Product Change Notification (PCN)

PCN #: 10F-2021

DATE: 11/3/2021

5.1 Base Part Number Changes (Module Label)

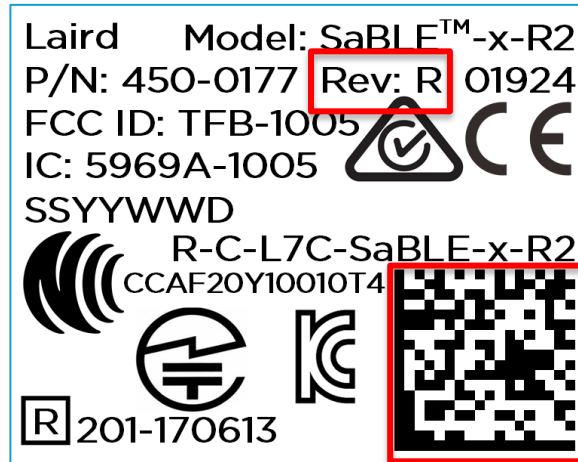
- Label updates have been made on all base modules to include the Korea certification logo and certification ID
- UKCA Logo added to module packaging labels (Tape & Reel, Cut Tape, and Carton) due to no room on the module.
- Upper-level assemblies have been up rev'd due to this change.

- Revision change available as revision number printed and within the barcode for all labels.

5.2 Top Level Part Number Changes (Cut Tape and Tape & Reel Label)

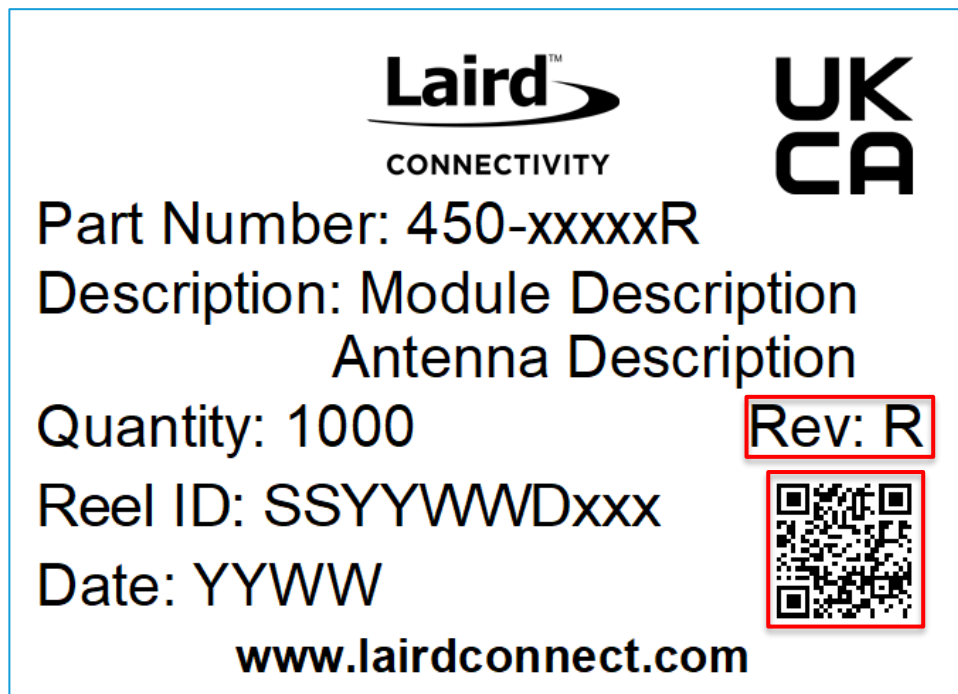
- Revision change available as revision number printed and within the barcode for all reels.

- Revision change available as revision number printed on all cut tape packages.
